Final Interchange Justification Report

Interstate 95 and Matanzas Woods Parkway

Flagler County

December 2010
Revised February 2011

Figure 4-3

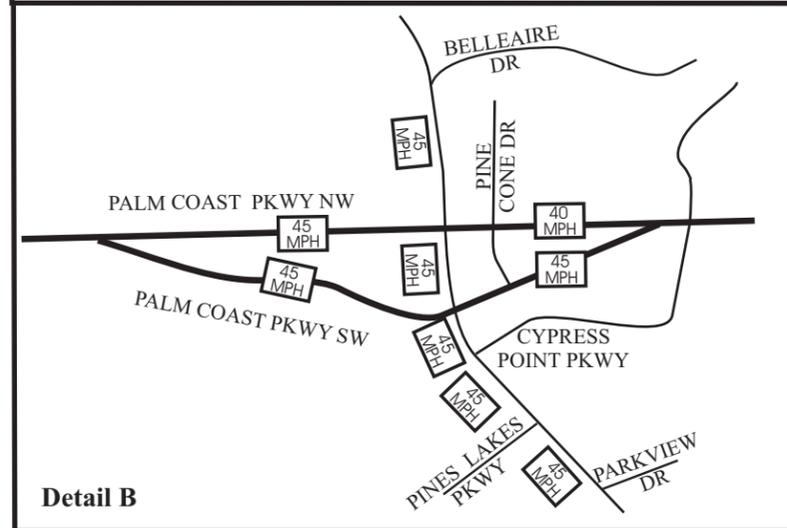
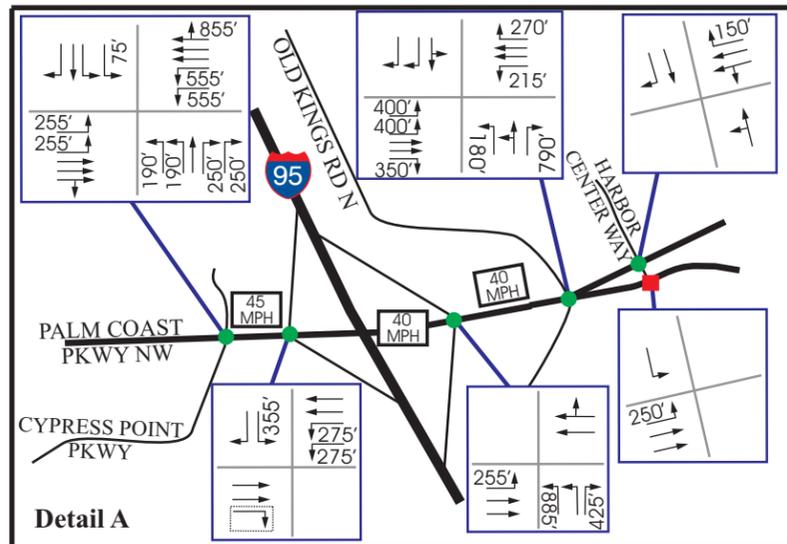
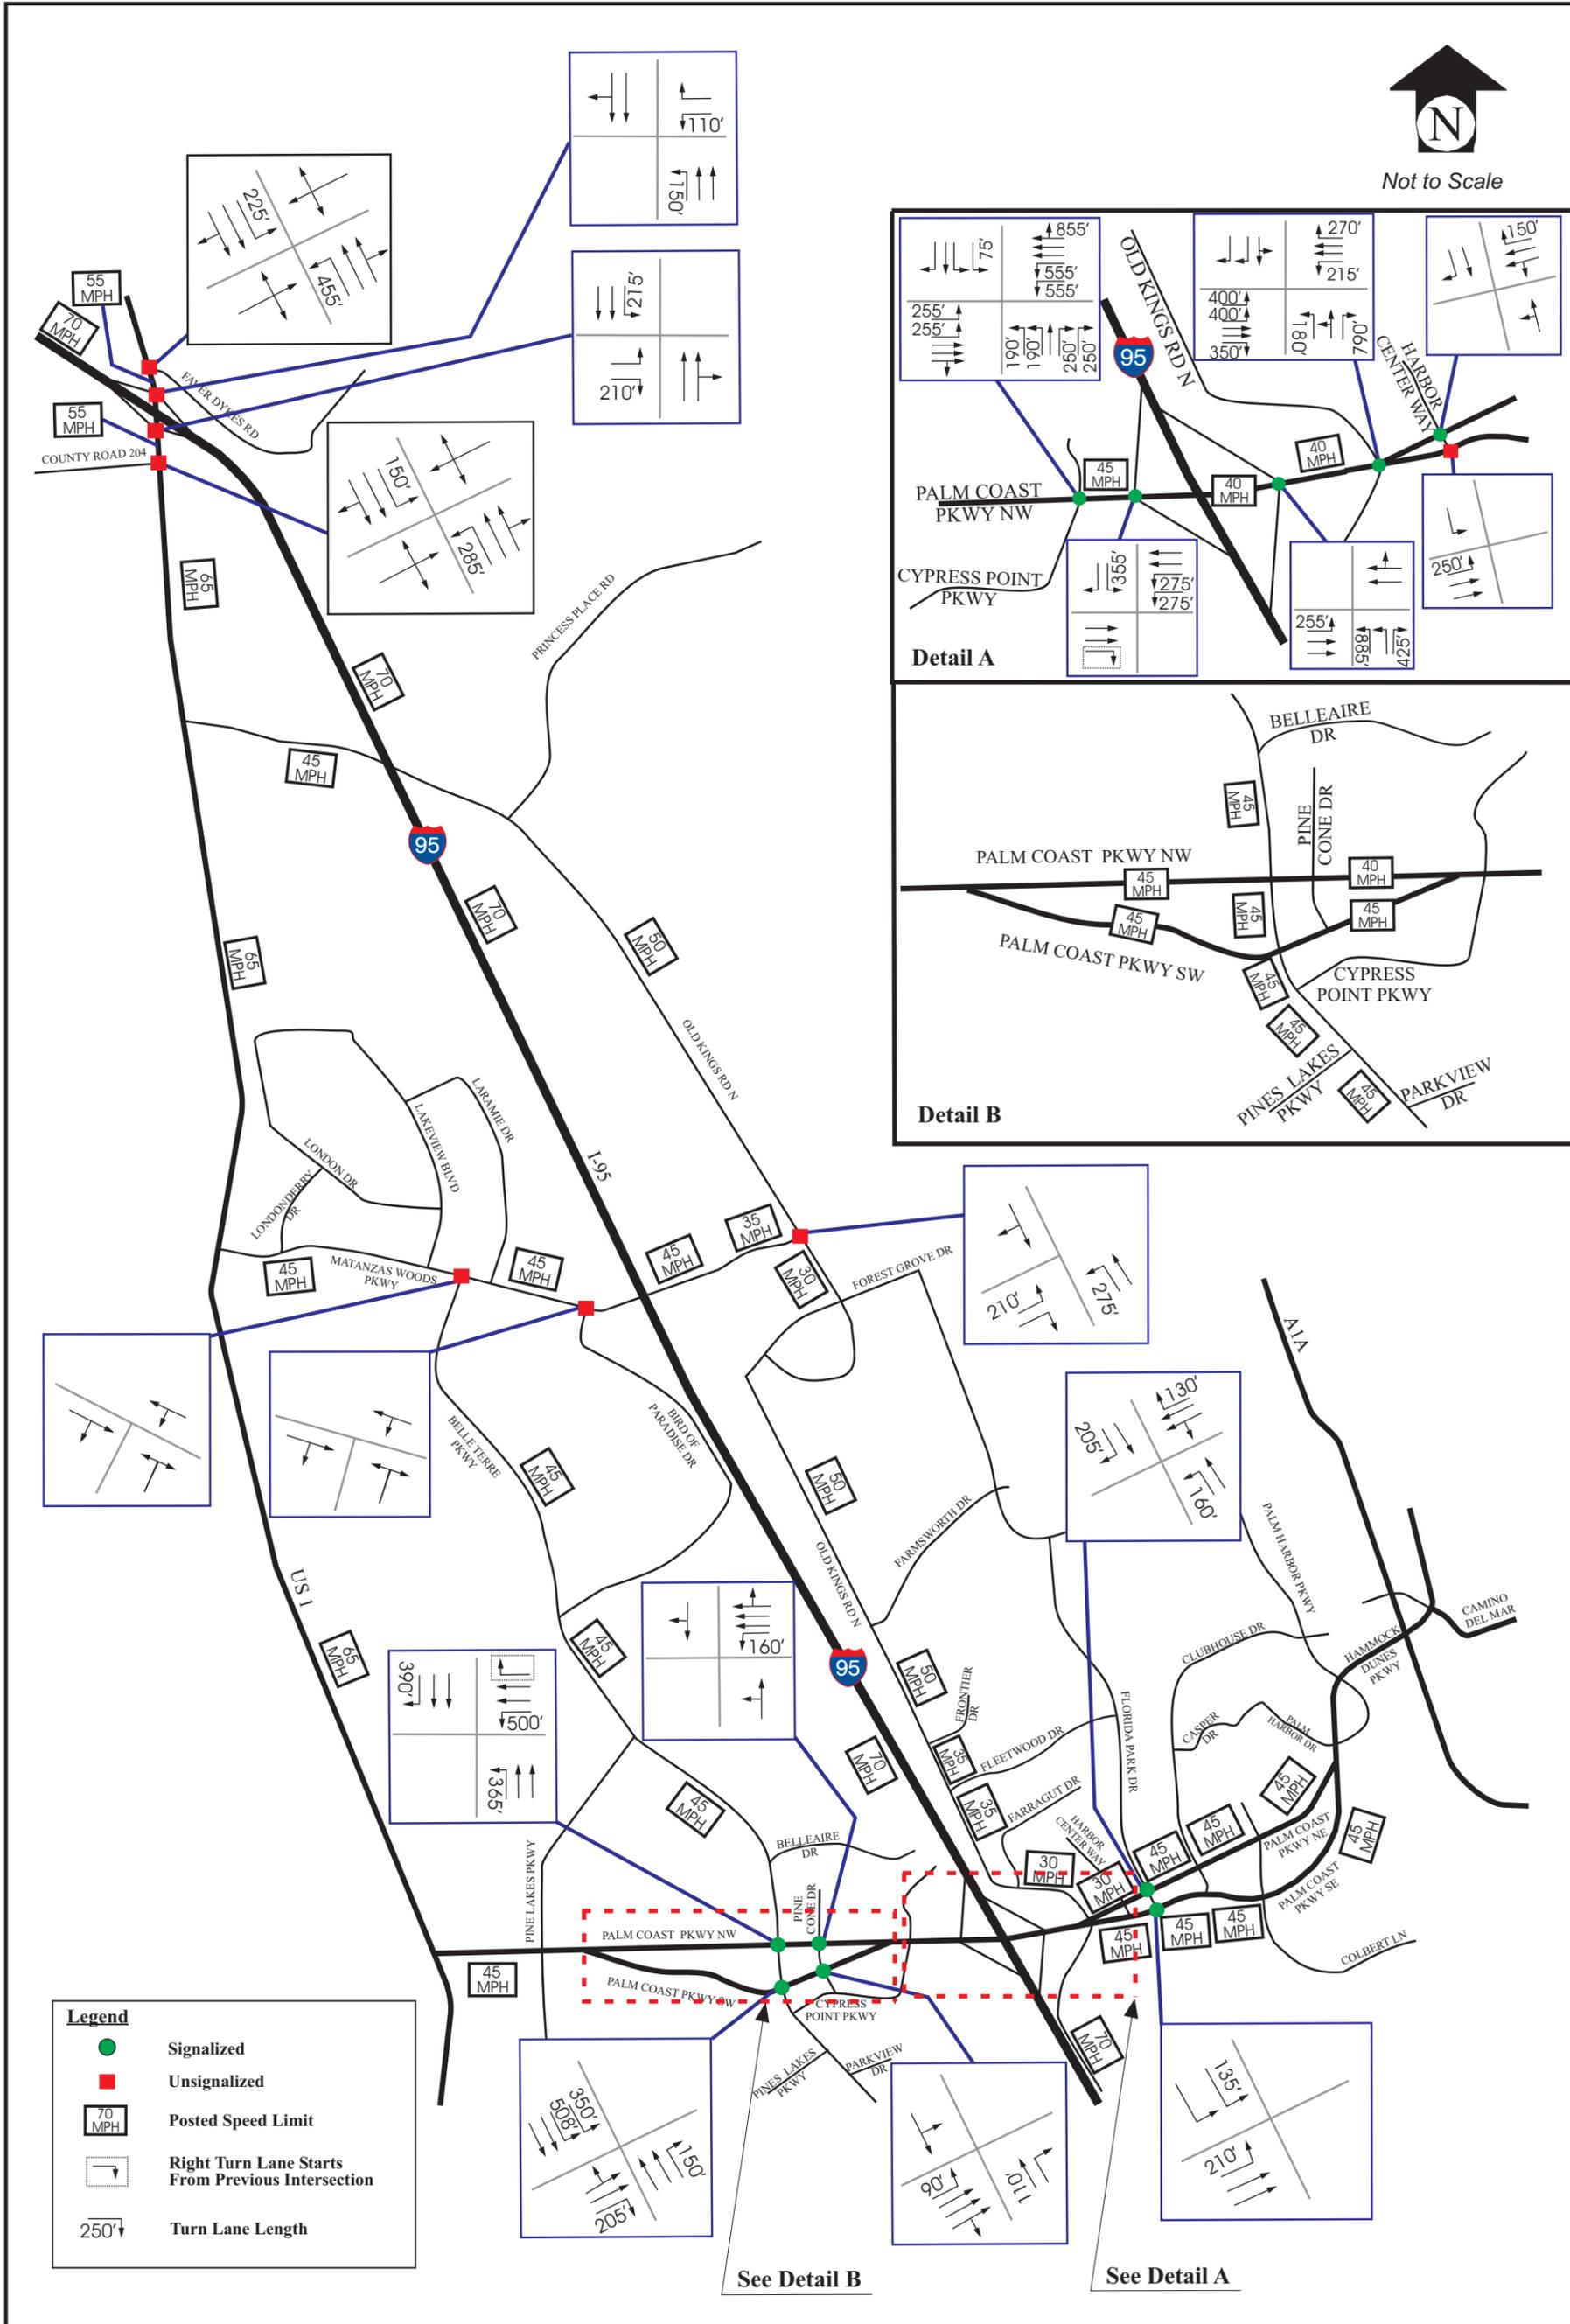
1. Comment 3 from August 2010 submittal has not been addressed. Figure 4-3 (previously figure 5) still shows 2 eastbound lanes at the intersection.

Comment 3: Figure 5 – For Palm Coast Pkwy NW/Cypress Point Pkwy intersection, 2 eastbound lanes are shown in the figure but aerial photography (from Google) shows 3 eastbound lanes. The third through lane is a shared through/right turn lane. Please check.

Response: Figure 4-3 has been corrected to show 3 eastbound lanes at Palm Coast Parkway and NW/Cypress Point Parkway. The related intersection analysis was audited and updated as needed in Table 4-2 (now Table 4-1) and Appendix VI.

Response 3: Lane geometry has been corrected to a shared through/right lane. Figure 5 is now Figure 4-3.

Figure 4-5

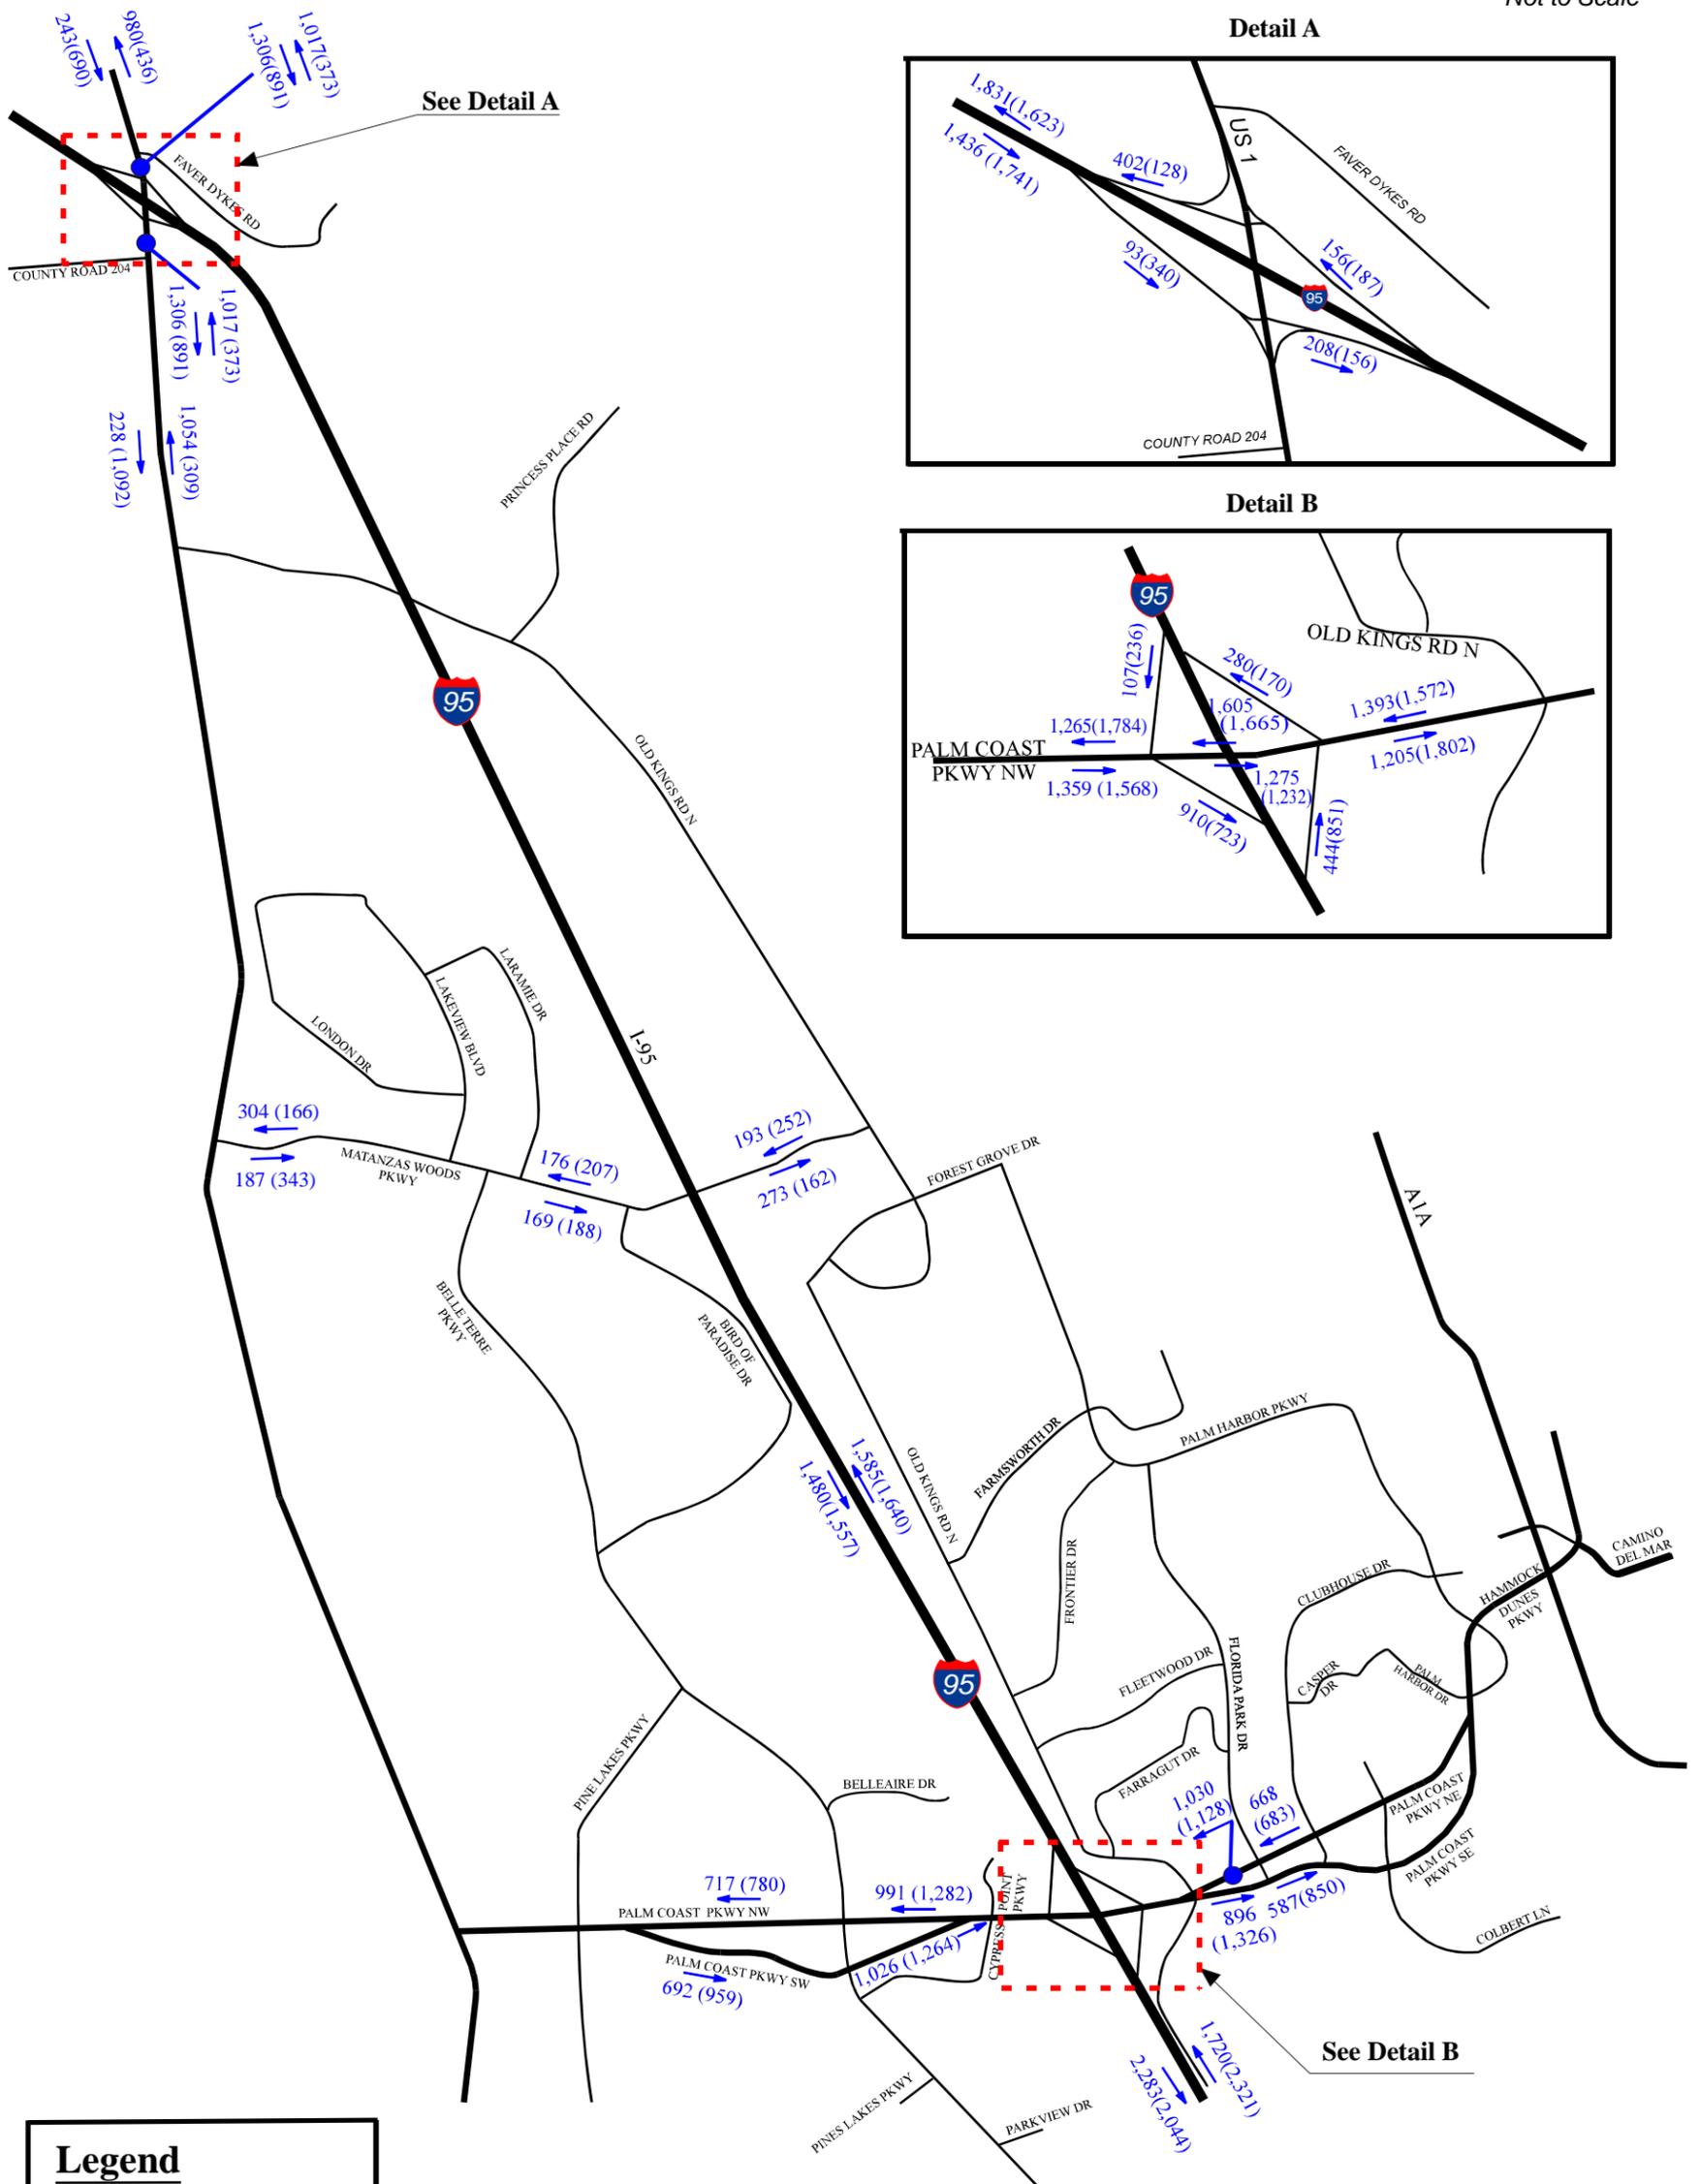
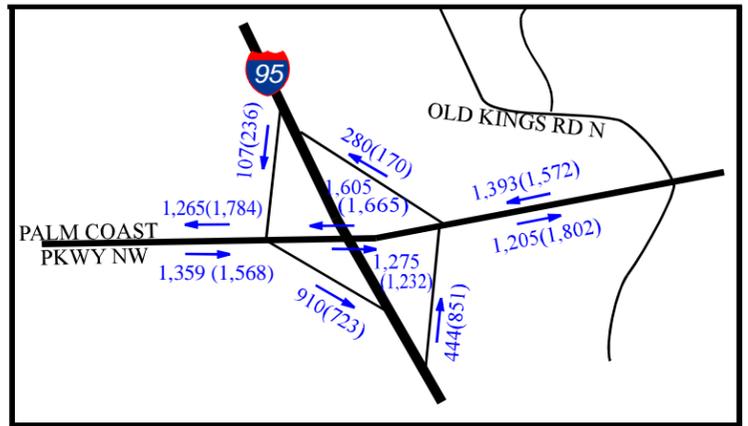
Comment 6: Figure 7 – Traffic volumes along I-95 are not balanced. Please check. Also provide ramp volumes in this figure.

6. Figure 7: change 2009 pm peak hour EB directional volume east of Palm Coast Pkwy at I-95 NB ramp terminus from 1,1802 to 1,802 (typo in Detail A inset).

Response 6: Figure 7 has been revised to show balanced I-95 volumes. Figure 7 is now Figure 4-5.

Response 6: The typo in Figure 7 has been corrected. Figure 7 is now Figure 4-5.
